8-10 New McLean Street

Urban Design Study

Prepared for
DPHI

Issued
June 14 2024

Envelope Development
Solar Compliance

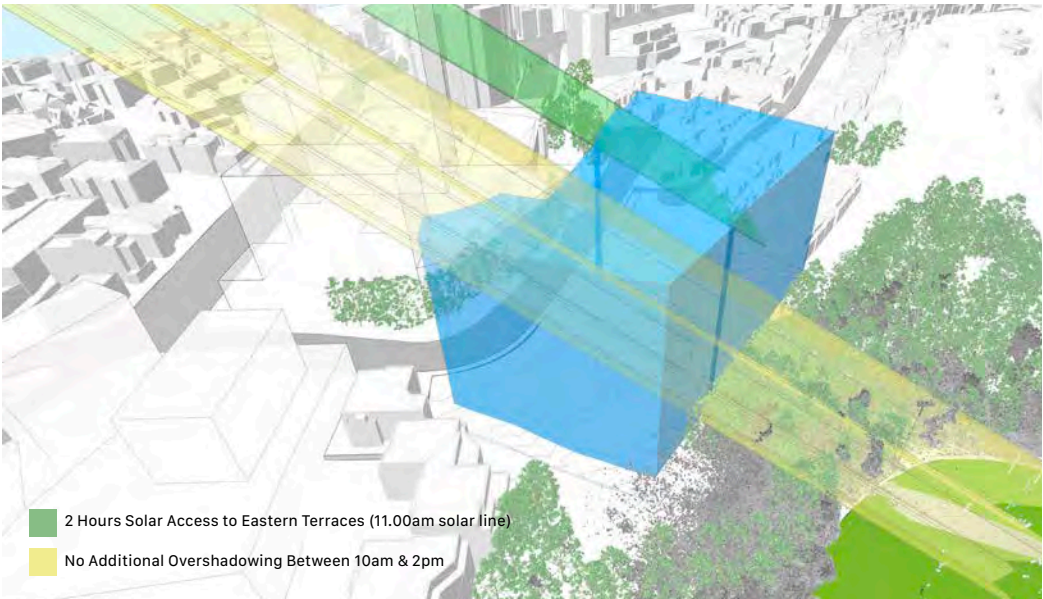
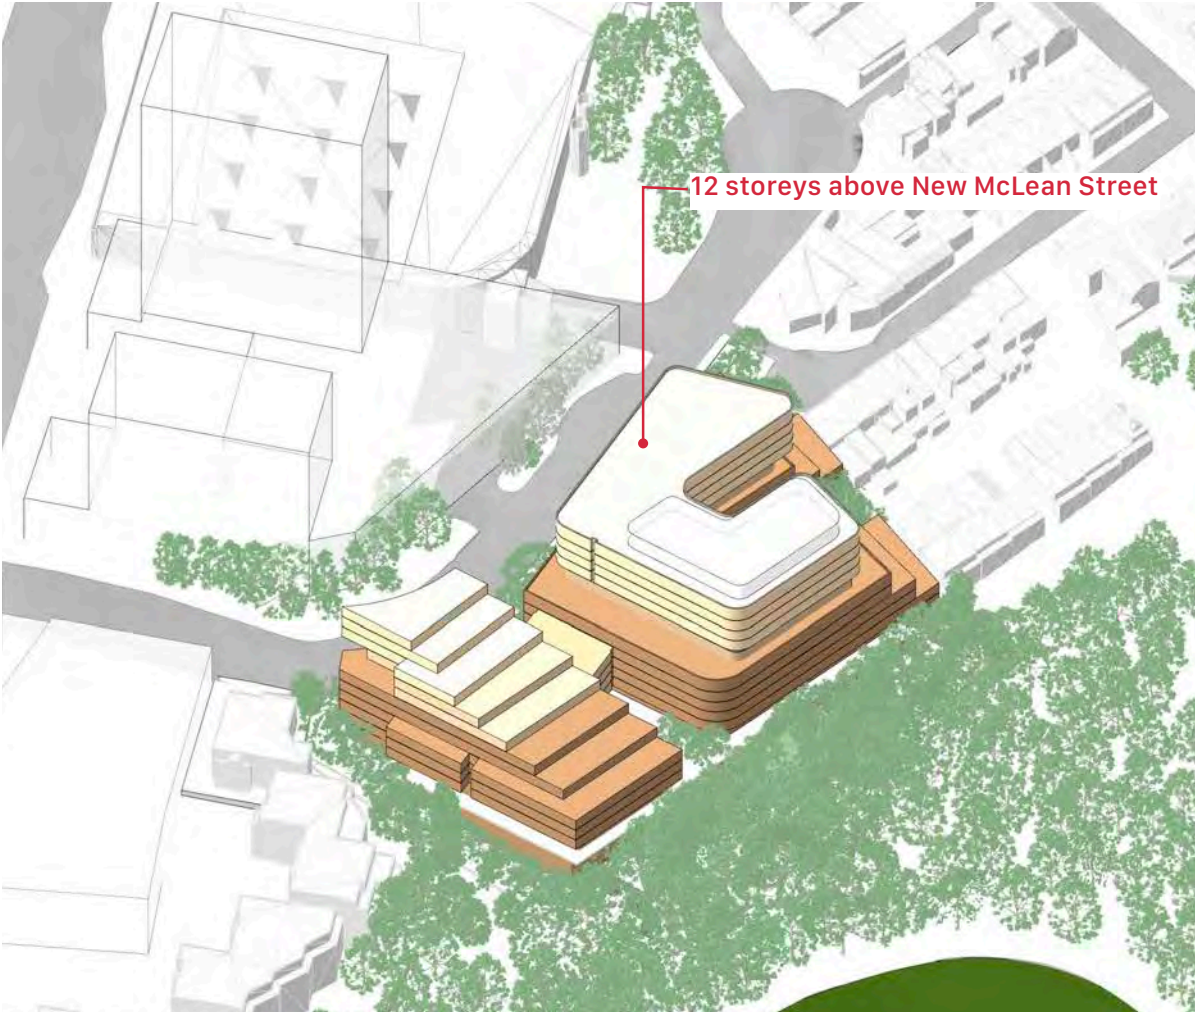
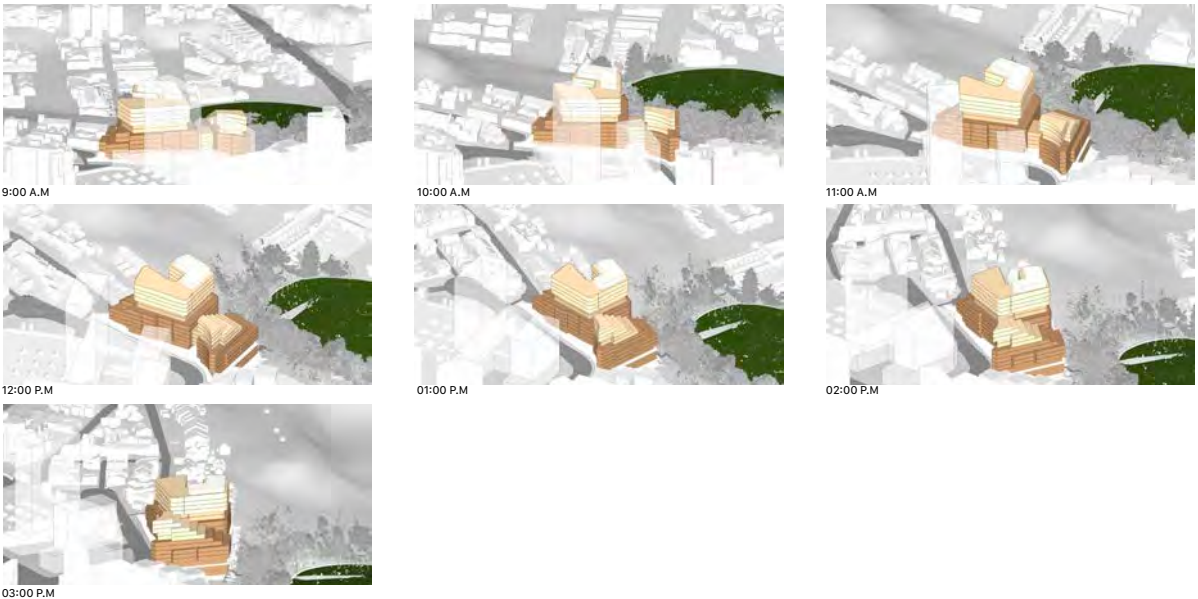
In review of the proponents response to the Strategic Planning Panel’s recommendations and design principles, we have made the following observations:

- The zero setback from the southern terrace houses raises concerns for interface and retention of existing significant trees along the south-eastern boundary
- a 12m separation between floors above 4 storeys on the southern mass would be difficult to achieve ADG compliance and for provision of residential amenity, the depth and shape of the footprints, in particular the podium levels of the south- eastern block, may be difficult to achieve an efficient layout and may also compromise residential amenity.

COMPARISON BETWEEN INTIAL ENVELOPE AND PROPONENT RESPONSE

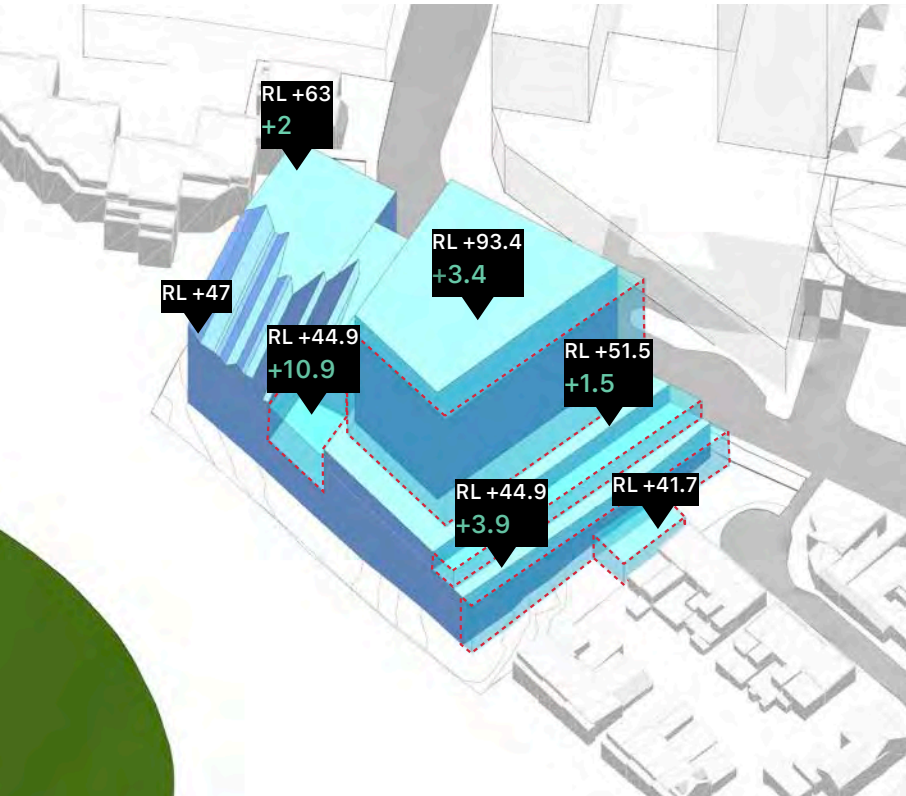
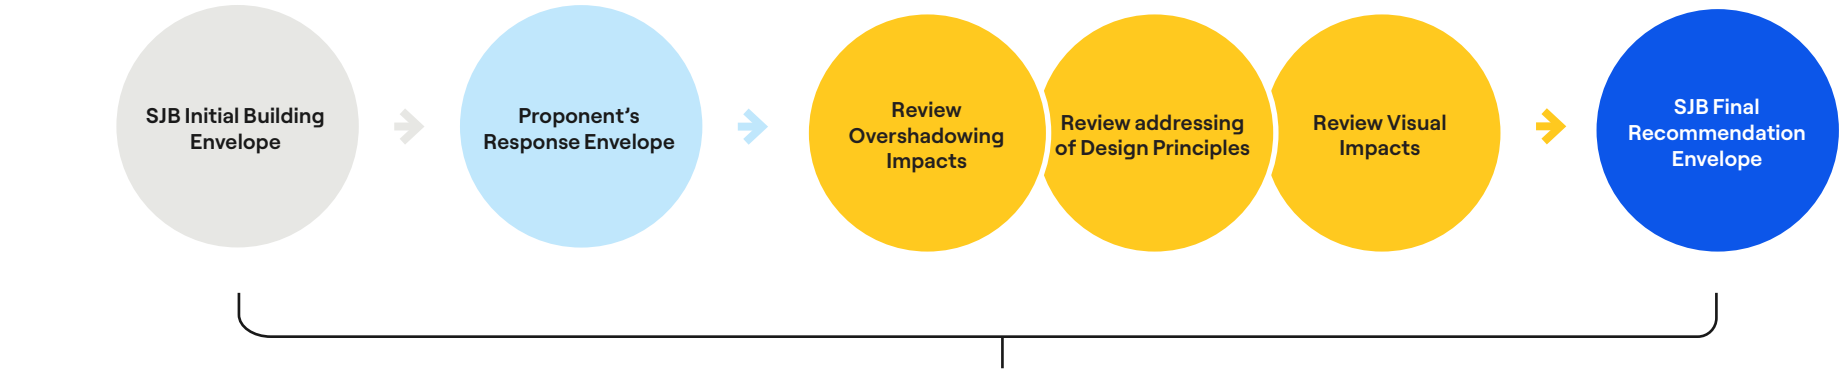
The design principles identified by the Panel formed the basis of SJB’s urban design analysis and their resultant preferred building envelope (SJB Initial Building Envelope). These principles have been used as criteria to assess the proponent’s amended envelope (Proponent’s Response Envelope) and determine the extent to which SJB Initial Building Envelope can be amended to accommodate the proponent’s five key feedback points.

Conversely, as well as exceeding the 12 storeys, the Proponent Response only achieves partial satisfaction with the principles relating to transition to the adjoining residential HCA or and the relationship to the Edgecliff Commercial Centre.

- Increase the envelope height (podium and tower) by 1m – 1.5m to accommodate NCC and ADG floor heights. Additionally, the increase in the tower height allows for an appropriate lift overrun, but does not permit an additional storey.
- Extend the footprints of the southern massing/podium further south to provide a variable setback of 8 to 12m, rather than a 12m continuous setback, without impacting the retention of significant trees, where possible.
- Extend the upper podium setbacks by 3m to the south-eastern boundary. The extension maintains an appropriate transition in heights to the surrounding context.
- The height of the built form within the central The central zone (Flex Zone) between the northern stepped built form and tower built form can accommodate increased building heights of up to 4 storeys.

Envelope & Controls

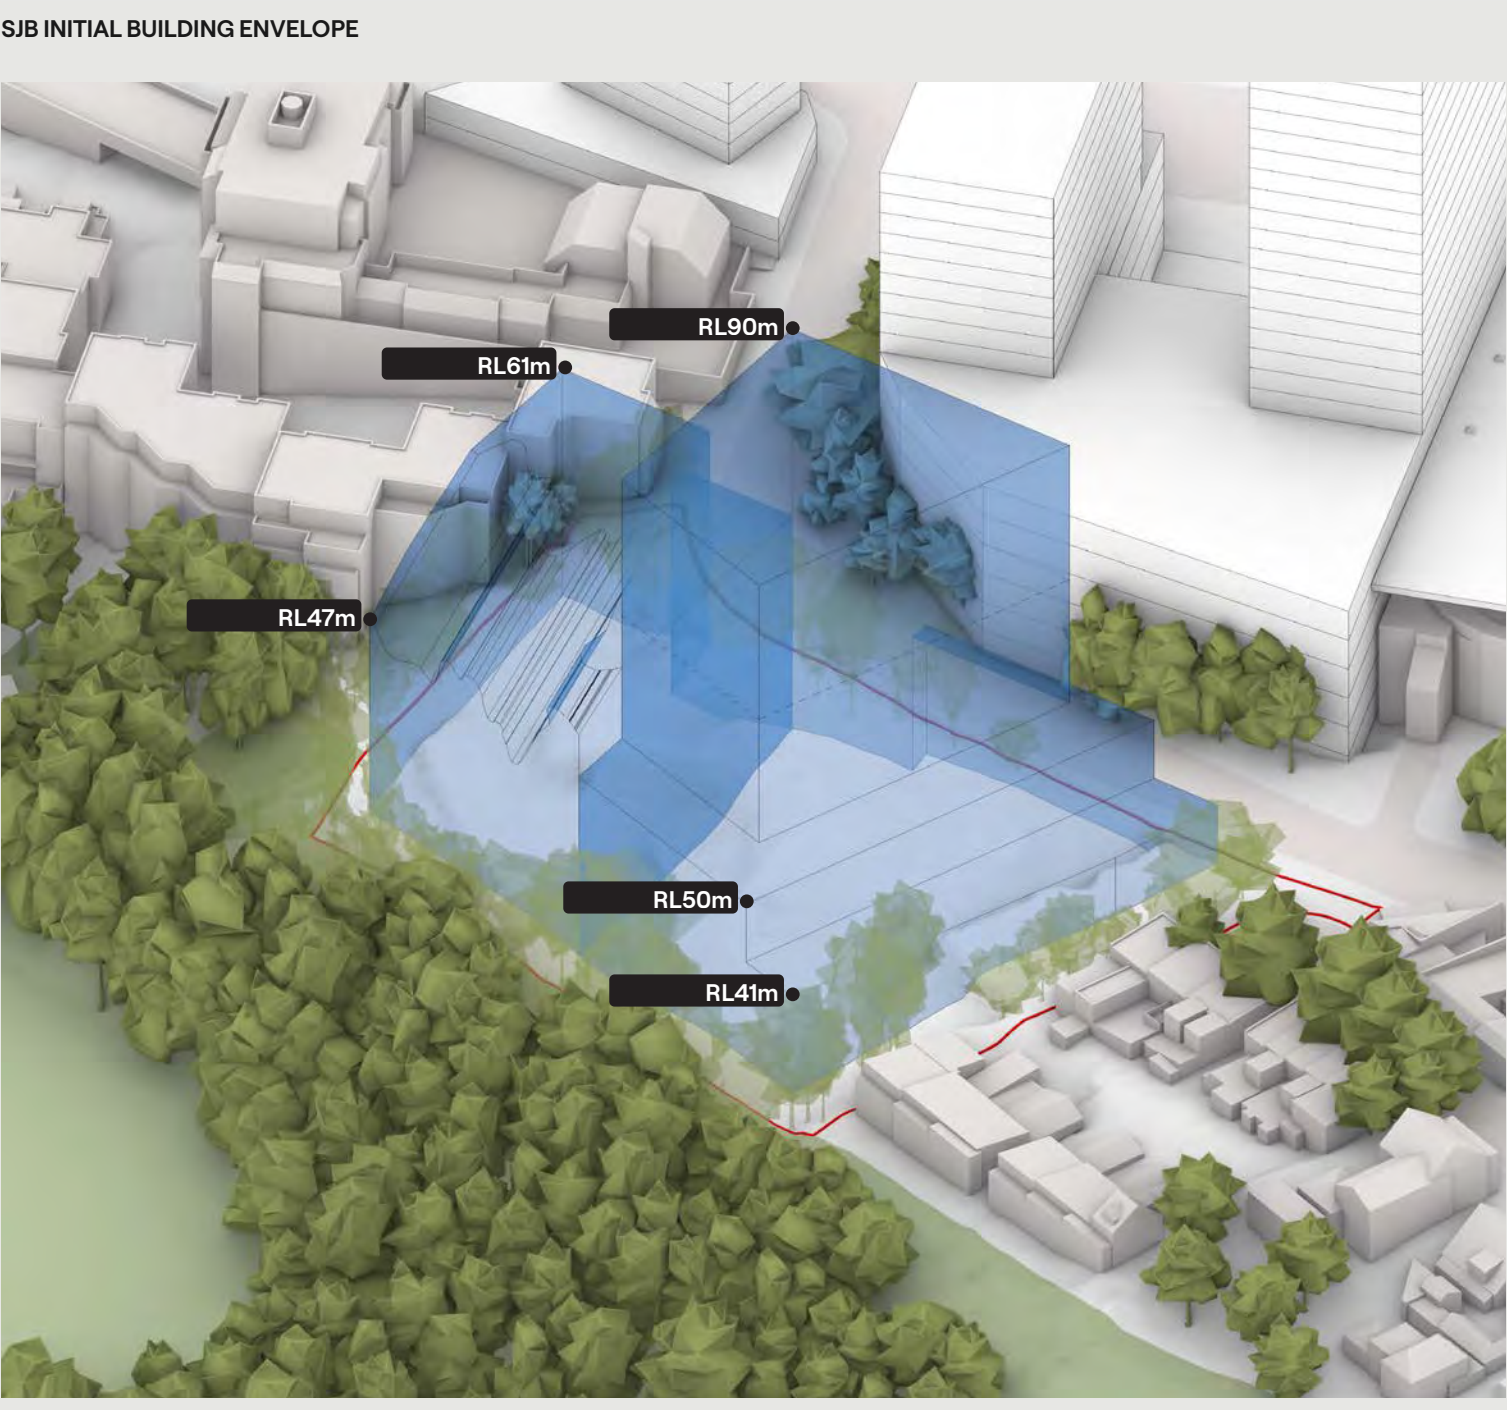
The Proponent response includes decreased setbacks along the southern and western boundary along with an extension of the envelope to capture the interface with the terraces to the east.

The overall height is also proposed to increase which could technically accommodate 19 storeys, as opposed to the recommended 18. Some minor changes have also been proposed to increase heights to accommodate BCA/NCC requirement.

The increased envelope would also impact biodiversity and the retention of some significant trees on the periphery of the site.

Views have been recreated from Urbaine Design Group’s visual impact assessment report to demonstrate a comparative assessment between the initial building envelope and the Proponent’s responding envelope.

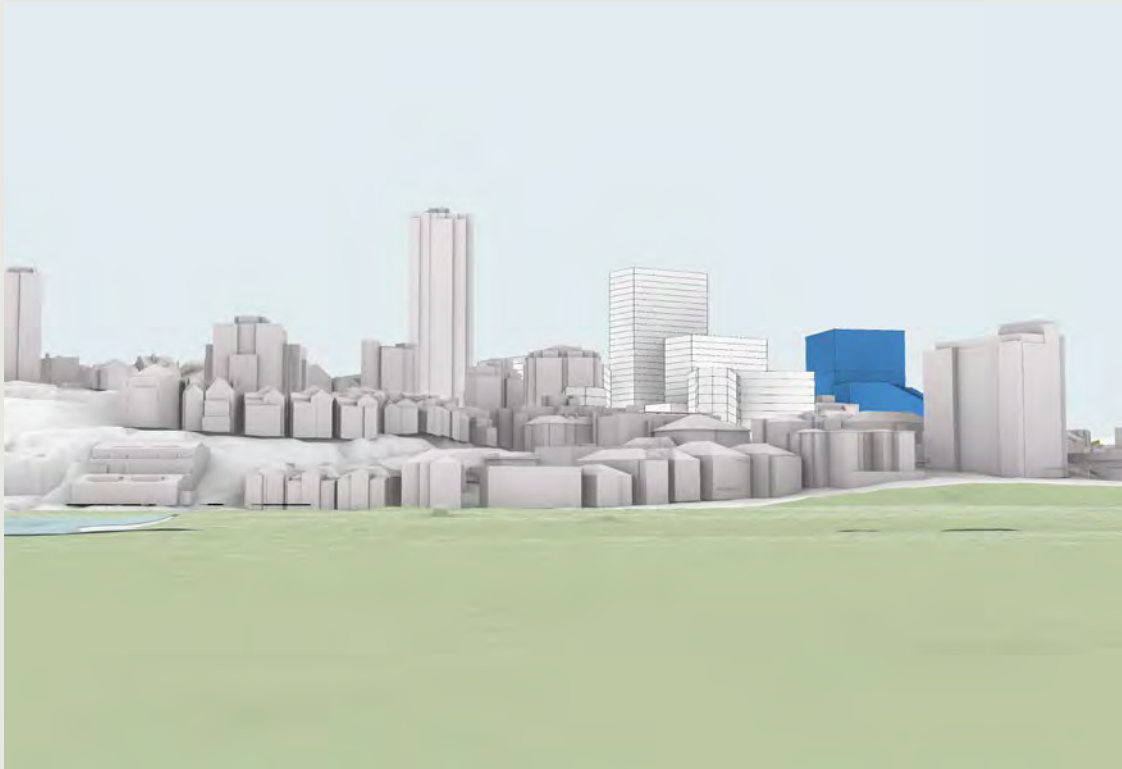
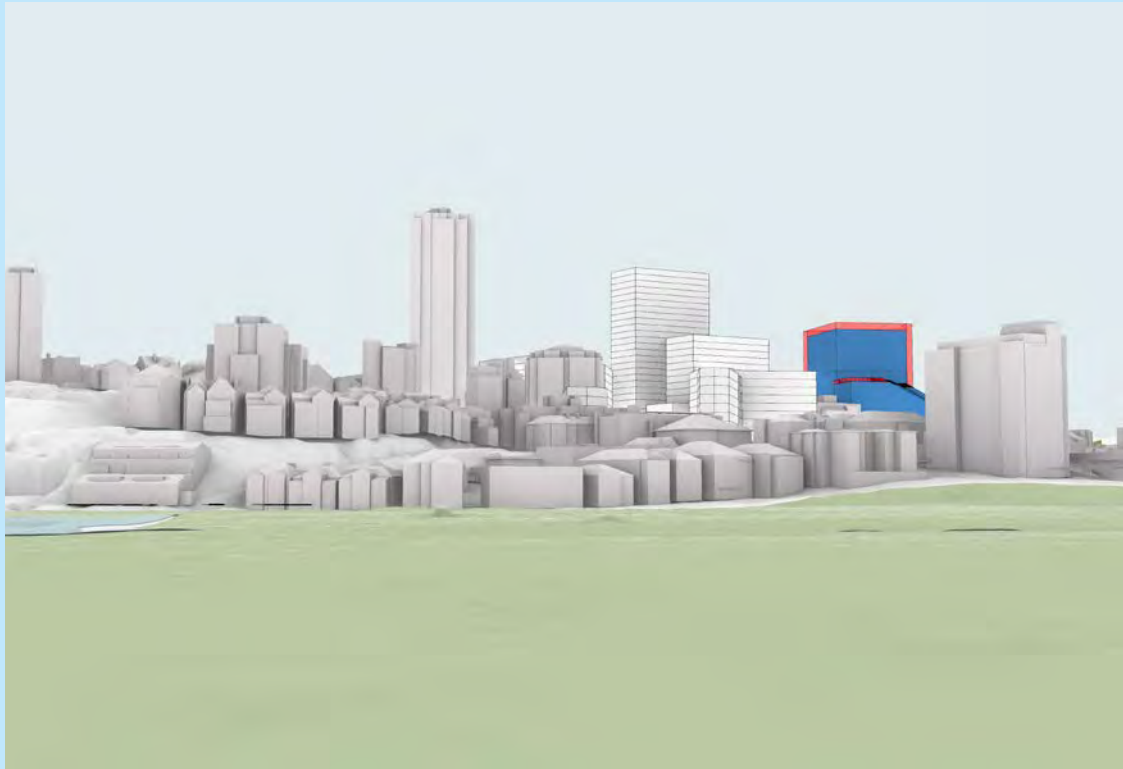
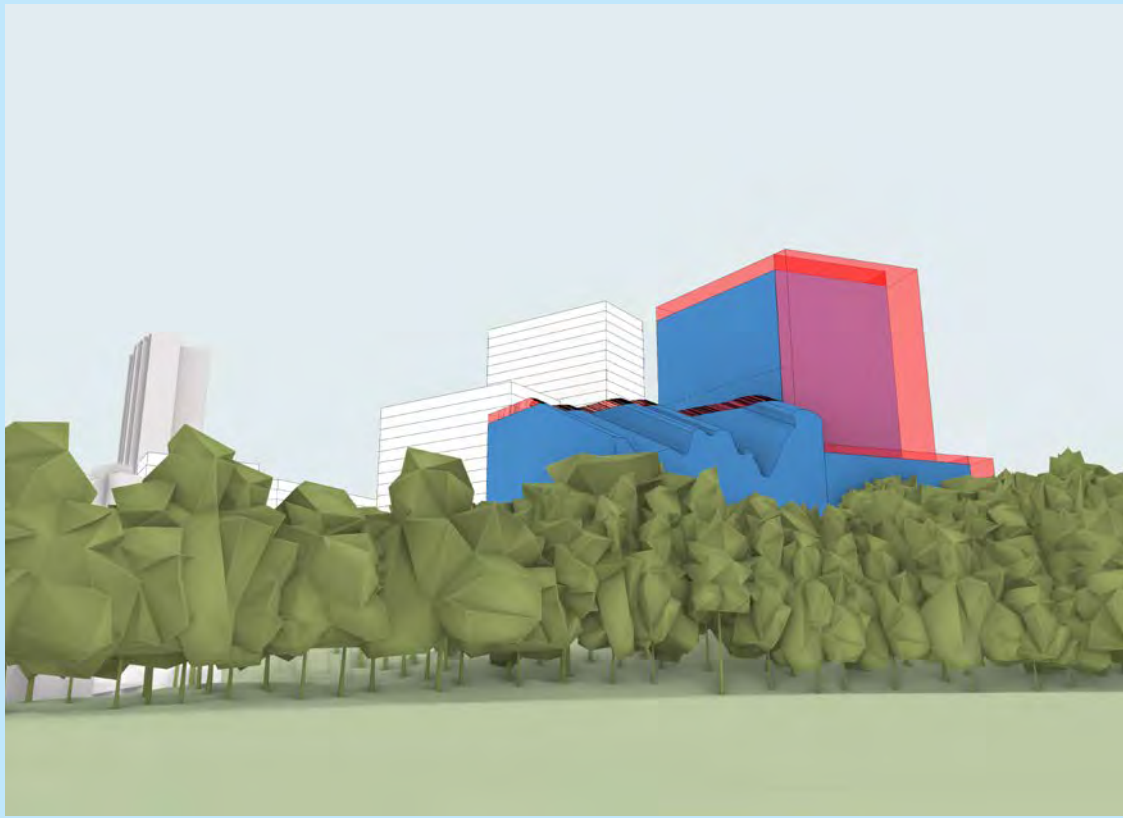
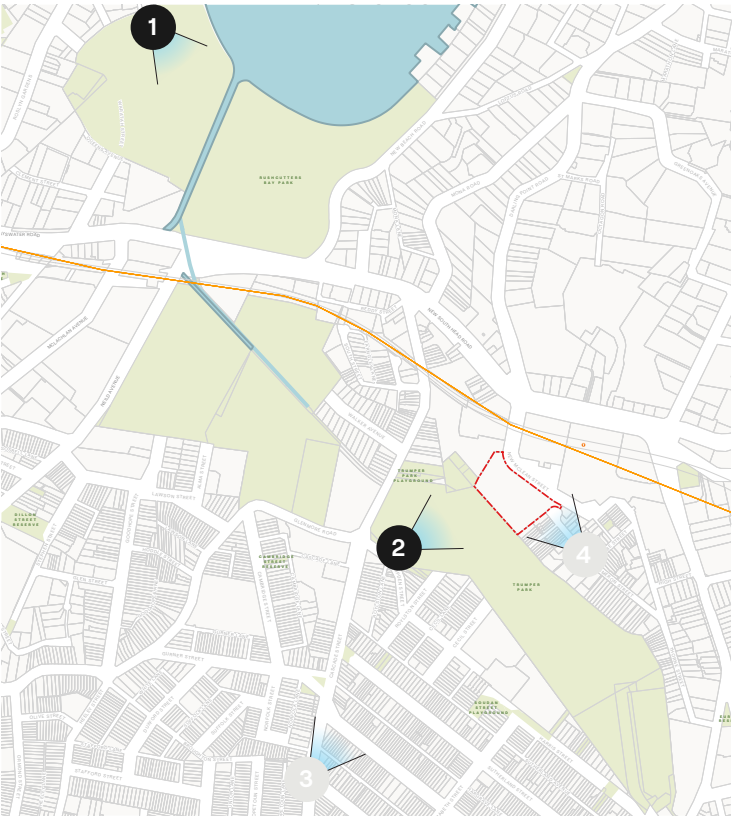
The increase in tower footprint in the Proponent’s responding envelope demonstrates a significant increase in bulk, increasing the overall visual impact.

In particular, the increase in envelope bulk as seen from Trumper Oval results in an inadequate transition in height and scale with the ECC. The extensions to the podium on the eastern boundary and increases in podium heights to accommodate terrace floor-to-floor heights is not seen to impact from these views.
